1955 Corvette: Service Bulletin: Oil Level Gauge Dipsticks

Model and Year: 1955 Powerglide Transmission

Bulletin No: DR-181

POWERGLIDE TRANSMISSION DIPSTICK MARKINGS

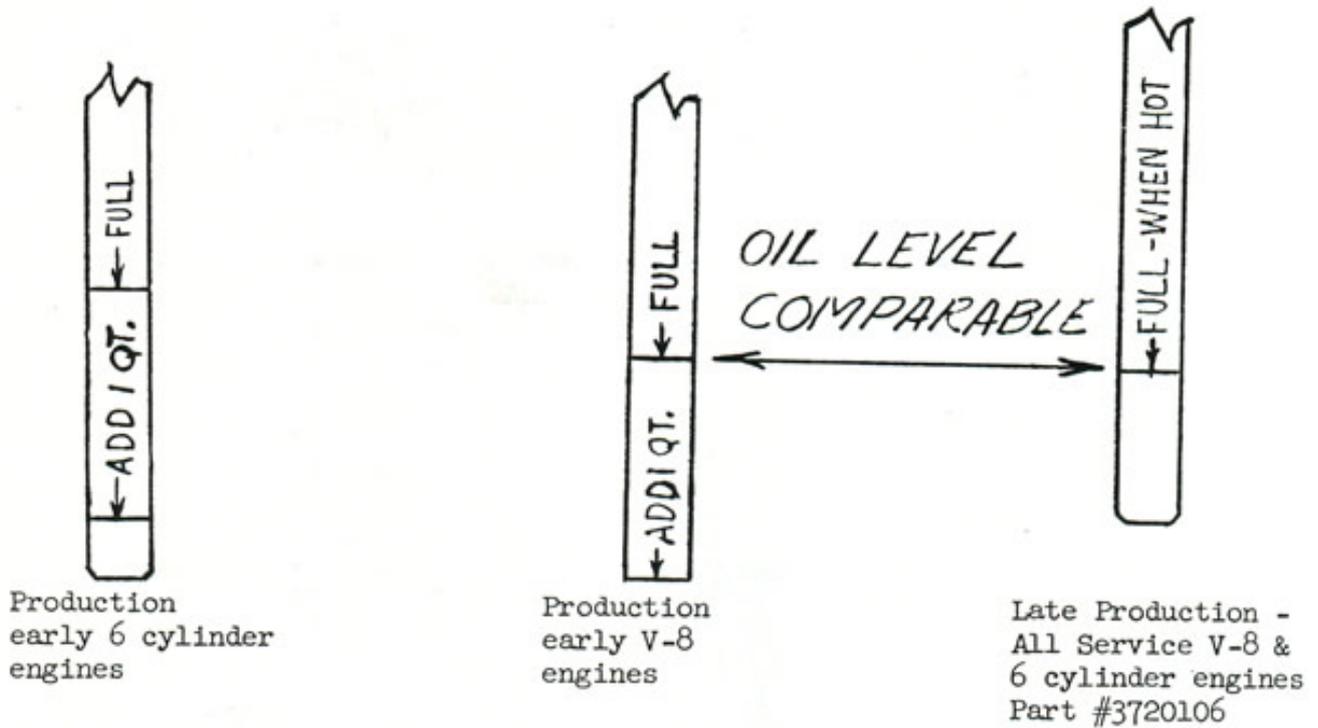
The following sketch shows the various Oil Level Gauge Dipsticks used with the 1955 Powerglide Transmission.

IMPORTANT - WHEN CHECKING OIL LEVEL

1. Engine should be idling.
2. Transmission control lever should be in the "N" position.
3. Transmission oil should be HOT.
4. Use the correct dipstick.
5. Check the level accurately.

Overfilling the transmission may cause lubricant loss at the Filler.
